FOREST LAKES  
PHASE 2

Major Amendment  
PUDSP -all sheets

PUDSP-18-001

DEVELOPMENT PLAN AND  
CONCEPTUAL SITE PLAN FOR PHASE 2

OVERALL

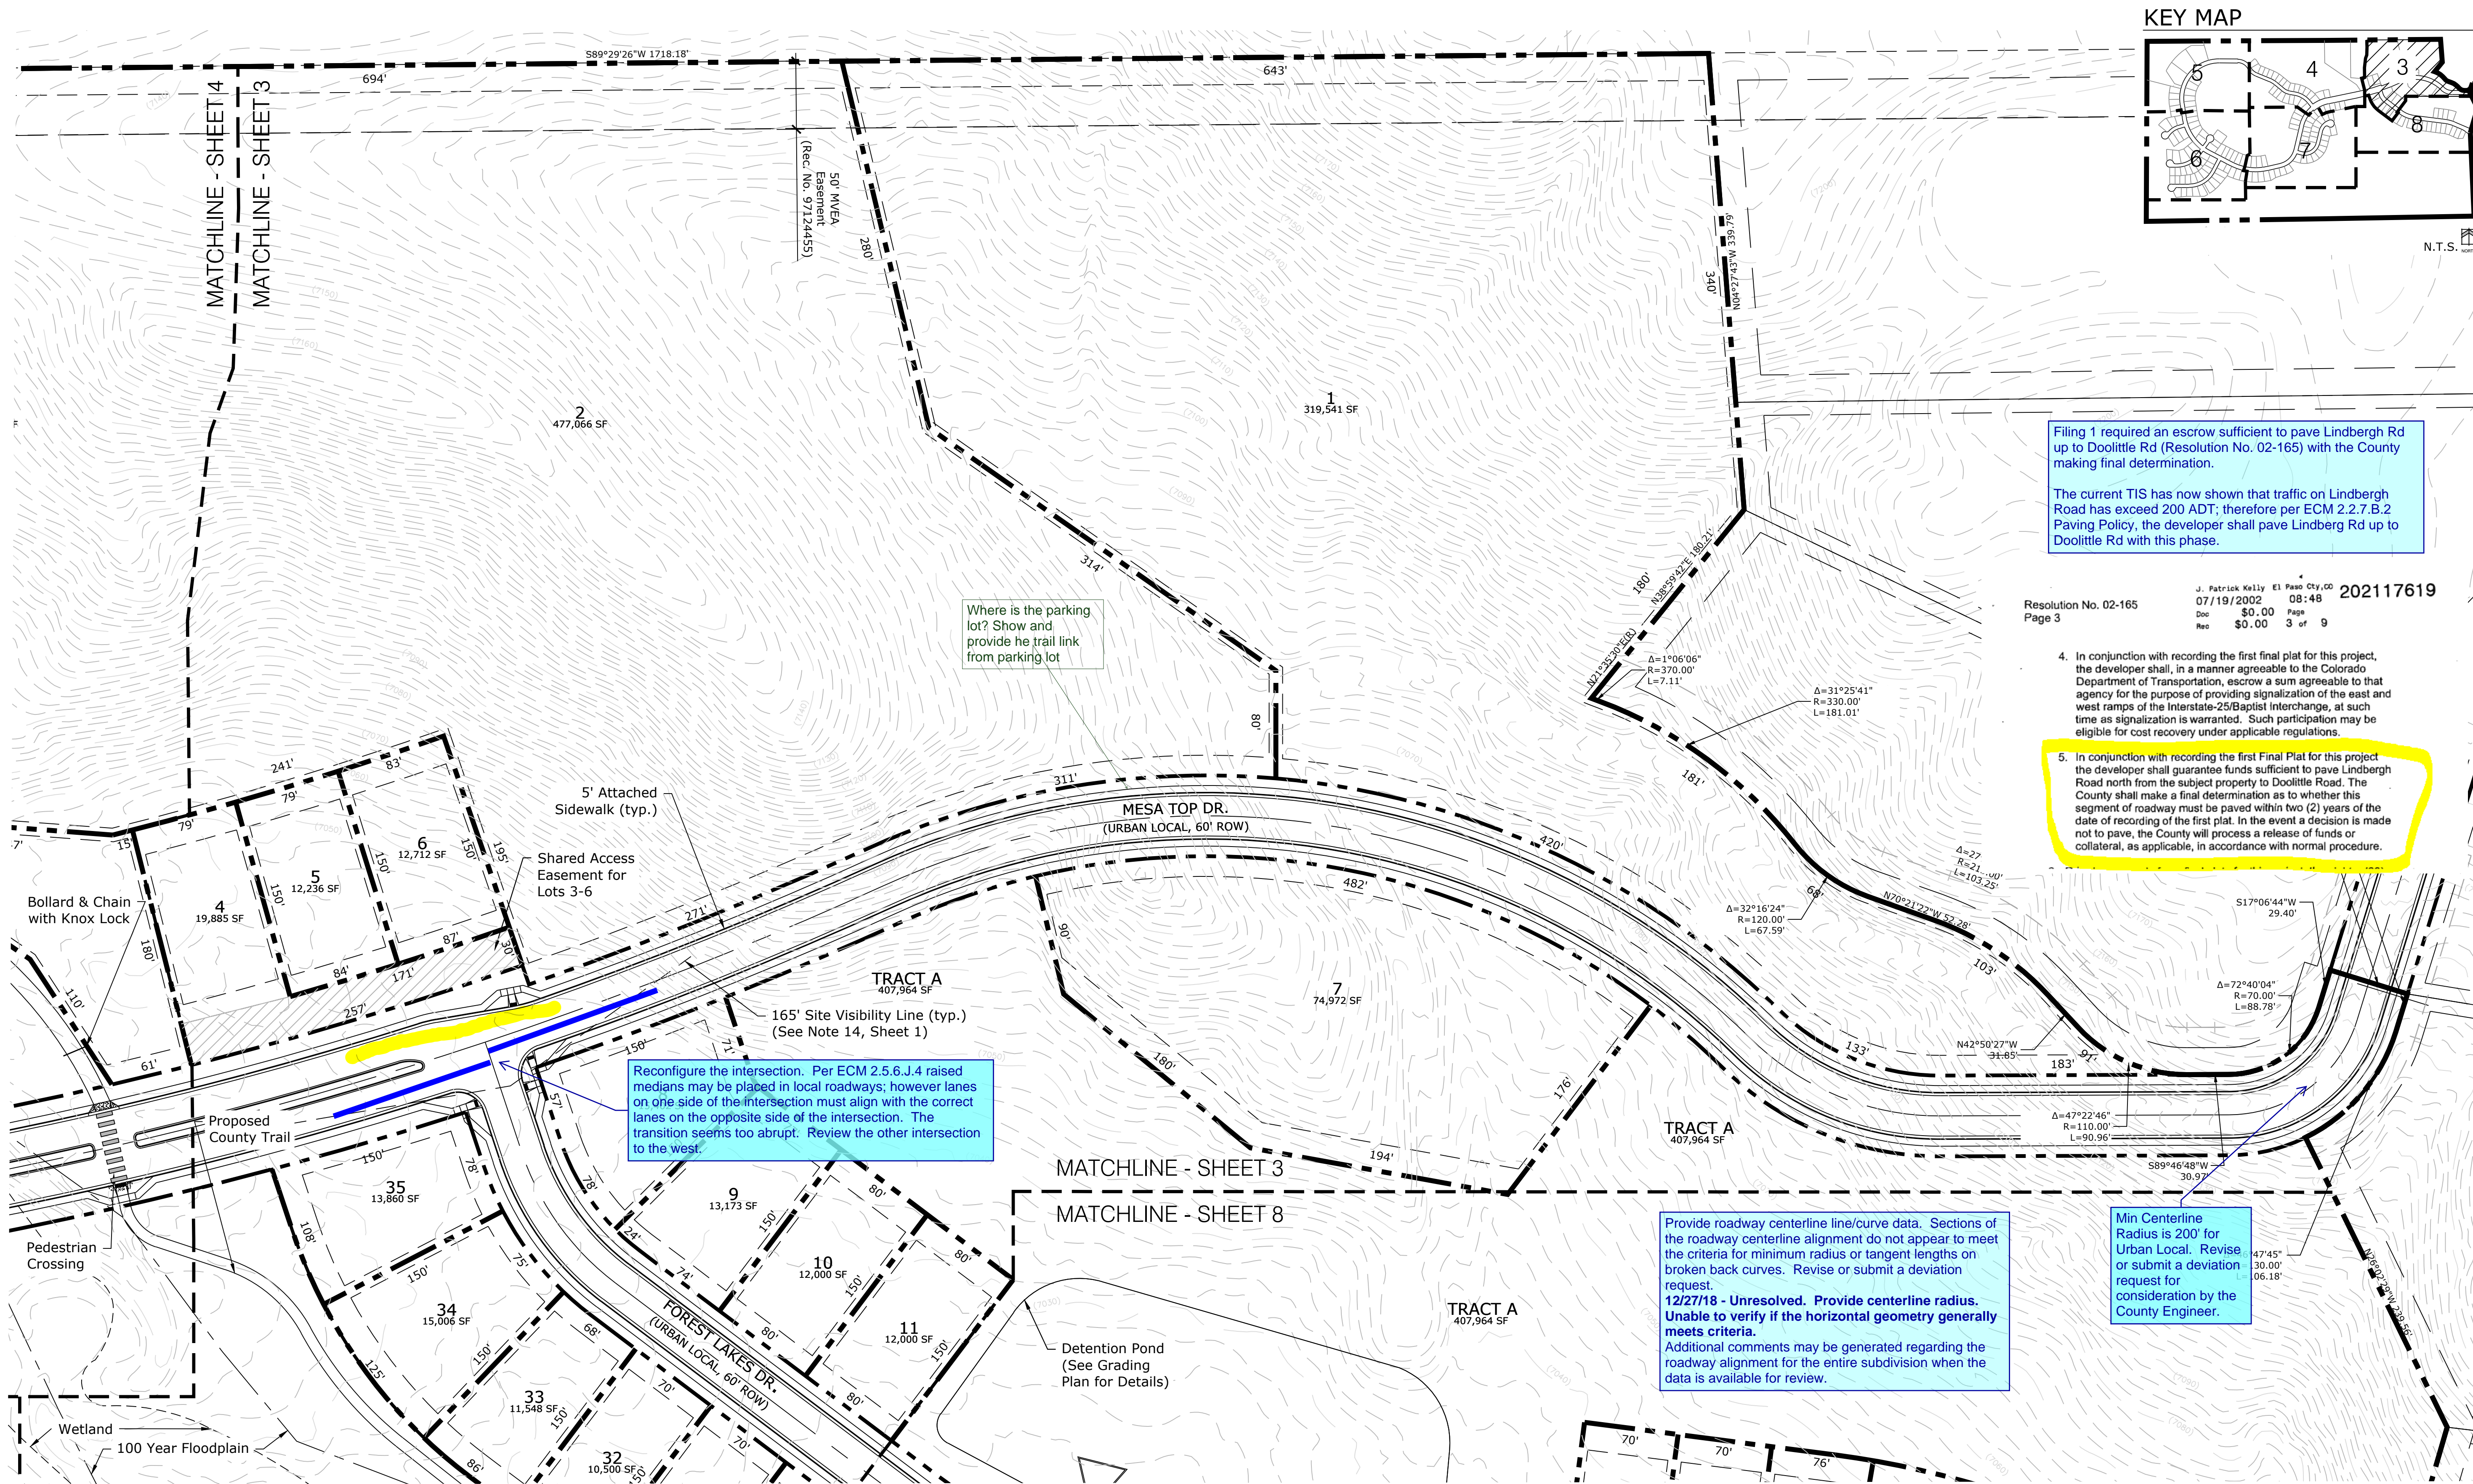
Filing 1 required an escrow sufficient to pave Lindbergh Rd up to Doolittle Rd (Resolution No. 02-165) with the County making final determination.

The current TIS has now shown that traffic on Lindbergh Road has exceed 200 ADT; therefore per ECM 2.2.7.B.2 Paving Policy, the developer shall pave Lindbergh Rd up to Doolittle Rd with this phase.

Reconfigure the intersection. Per ECM 2.5.6.J.4 raised medians may be placed in local roadways; however lanes on one side of the intersection must align with the correct lanes on the opposite side of the intersection. The transition seems too abrupt. Review the other intersection to the west.

Provide roadway centerline line/curve data. Sections of the roadway centerline alignment do not appear to meet the criteria for minimum radius or tangent lengths on broken back curves. Revise or submit a deviation request.  
12/27/18 - Unresolved. Provide centerline radius. Unable to verify if the horizontal geometry generally meets criteria.  
Additional comments may be generated regarding the roadway alignment for the entire subdivision when the data is available for review.

Min Centerline Radius is 200' for Urban Local. Revise or submit a deviation request for consideration by the County Engineer.

Where is the parking lot? Show and provide he trail link from parking lot

Water Tank , Mail Kiosk and Trail/ER DETAILS and

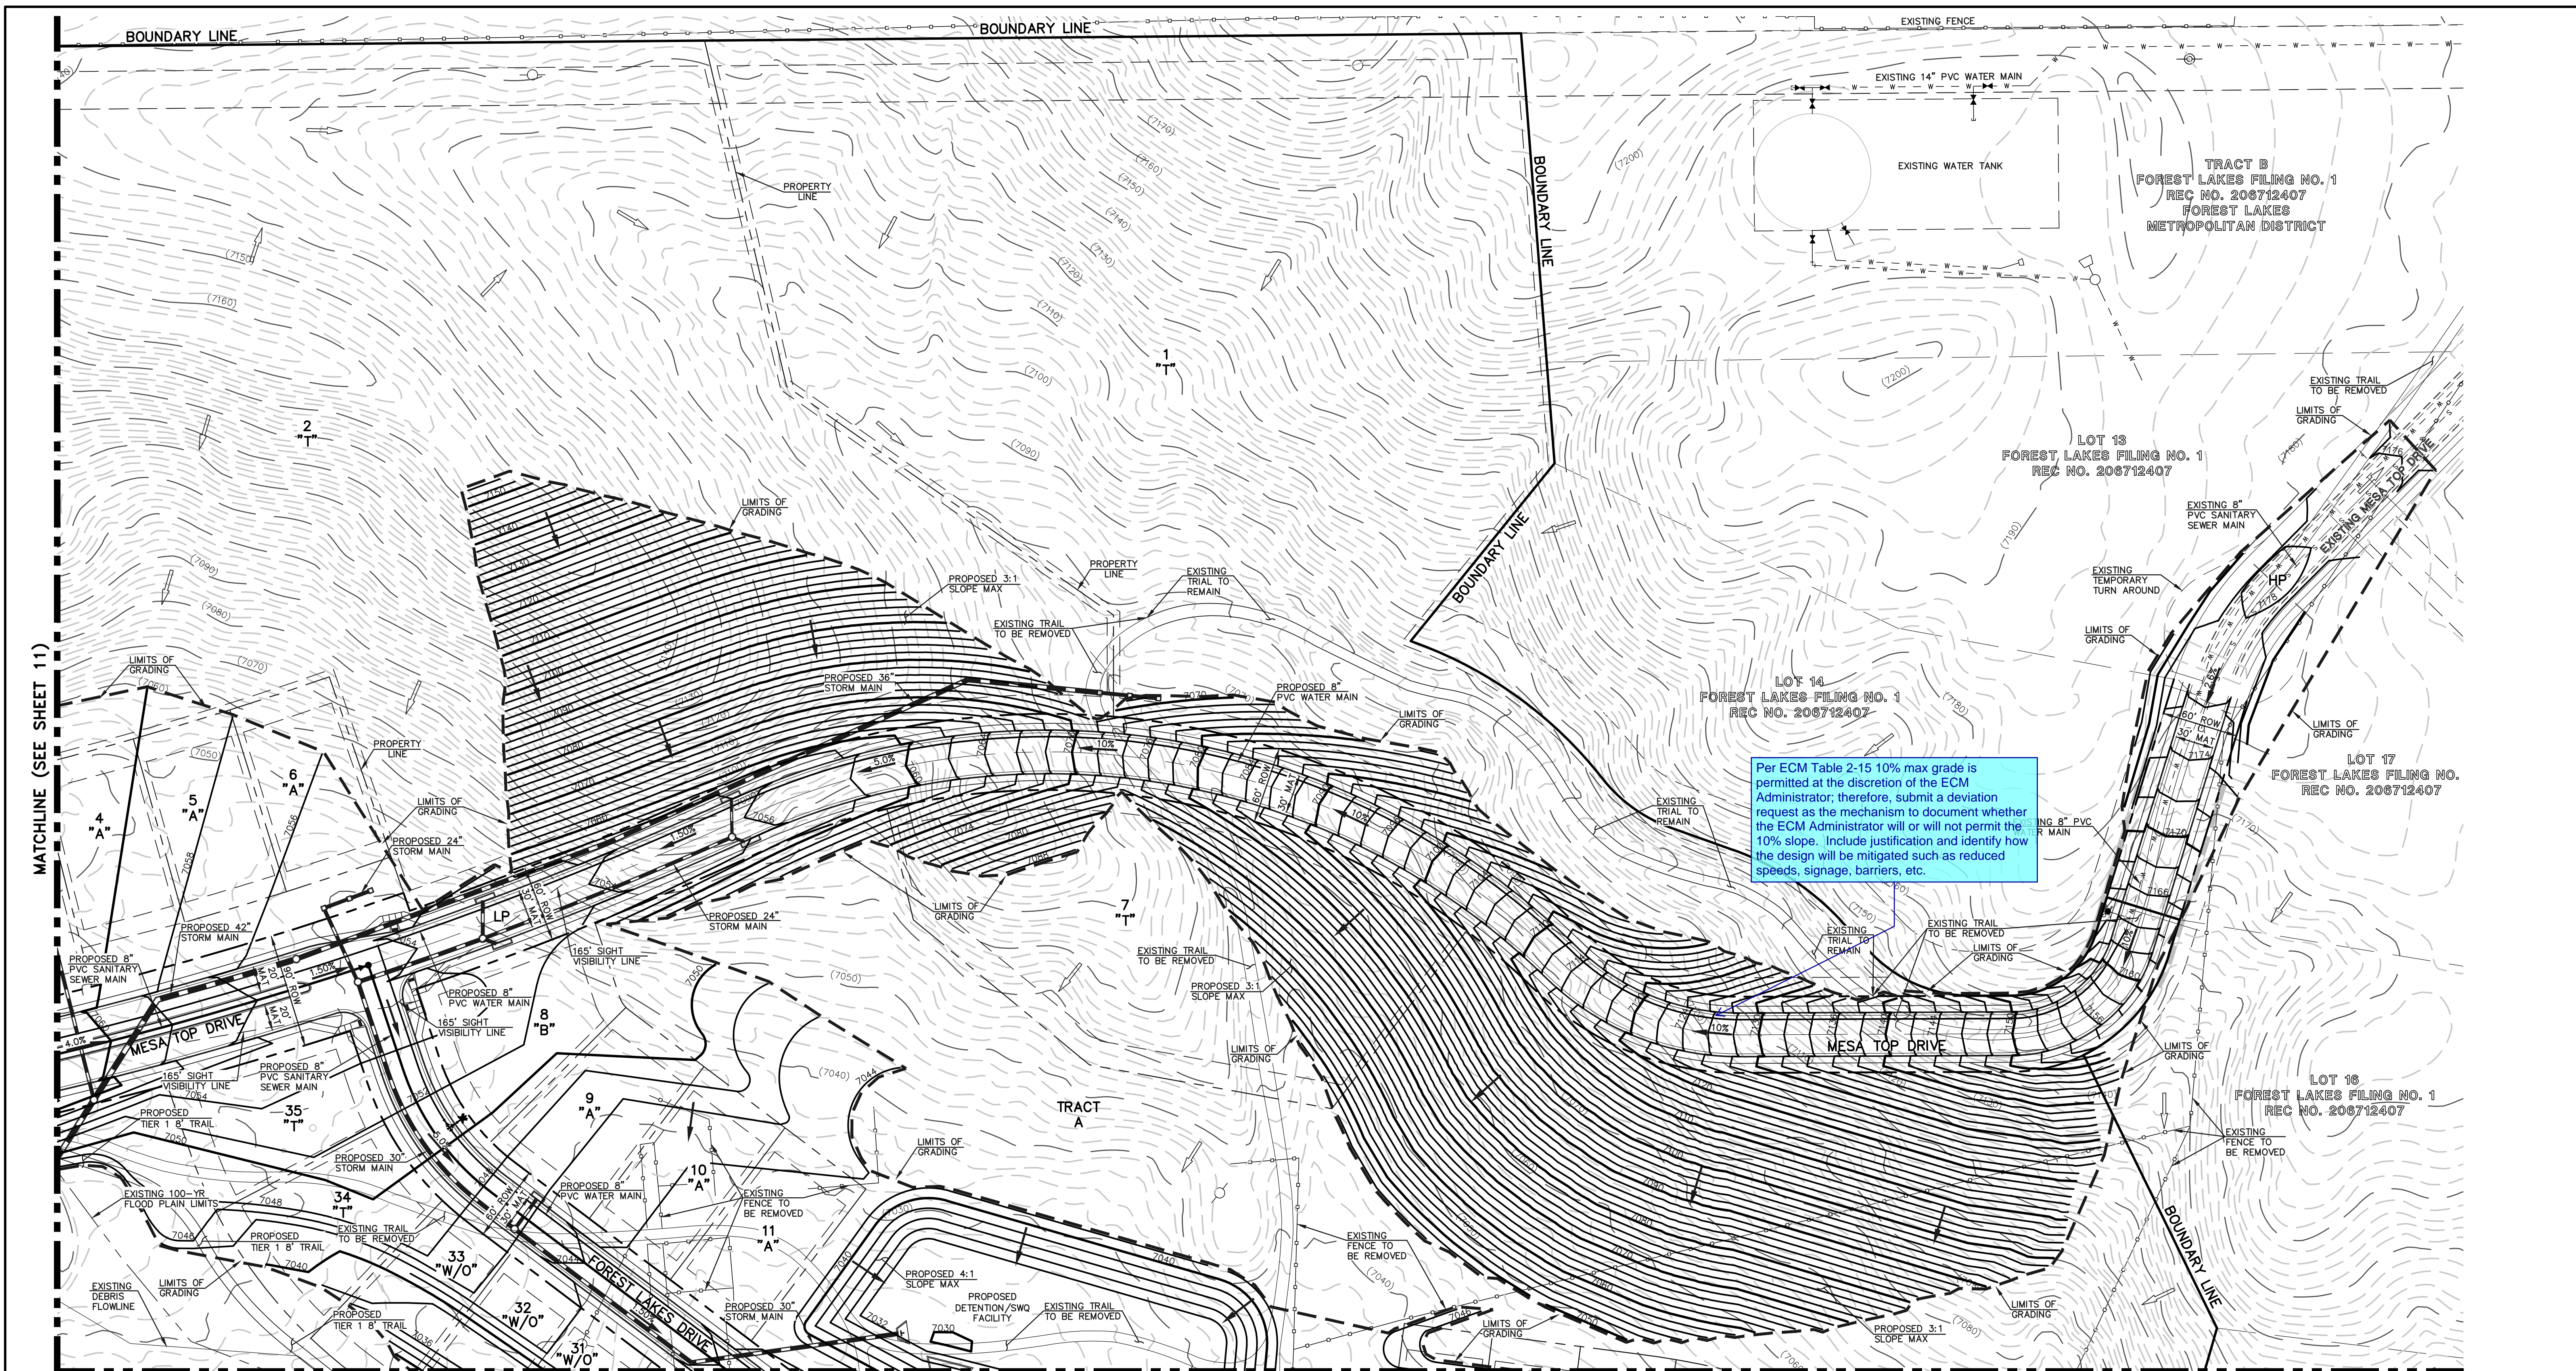
Mesa Top Parking Lot detail

entry sign(s) detail?

Emer Access cross section per Fire dept letter- Additional PUD modification ? - I think you encourage concerns not meeting the fire dept standards with the fire history- Staff recommends you meet them.

Per ECM Table 2-15 10% max grade is permitted at the discretion of the ECM Administrator; therefore, submit a deviation request as the mechanism to document whether the ECM Administrator will or will not permit the 10% slope. Include justification and identify how the design will be mitigated such as reduced speeds, signage, barriers, etc.
